CITY OF GARDEN CITY

File Number: PUDFY2021-0001
Location: 116, 118, and E. 33rd Street
Applicant: Jeff Hatch
Planning and Zoning: August 18, 2021
Design Review Committee Pre-Application Conference: June 21, 2021
Design Review Formal Hearing: July 19, 2021
City Council: September 13, 2021

Staff Report
 Prepared by Hanna Veal

SOUTHWEST ELEVATION

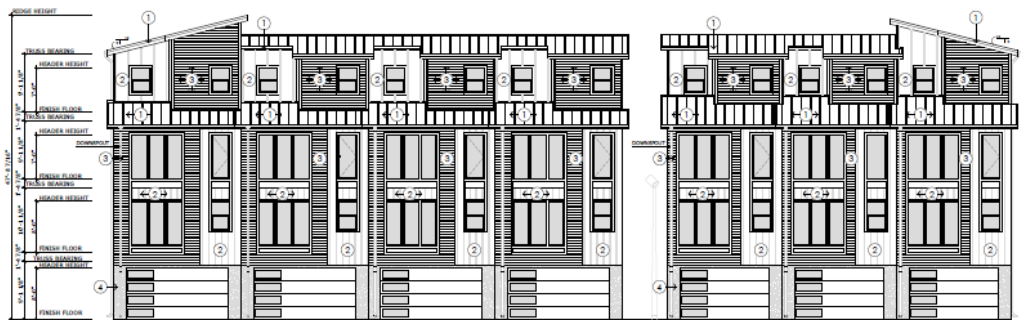
Design Review Committee comments from pre-application conference: "Perimeter landscaping along the Southeast property line is acceptable so long as there is additional structural design to help meet the intent of perimeter landscaping." The southwest façade has changed from the original proposal by including additional architectural features. These features include varying materials, wire mesh accents and a public art wall the corner nearest to 33rd St. The perimeter landscaping has not changed. The applicant has not officially requested a waiver for perimeter landscaping standards; however, staff has included it in the decision document.
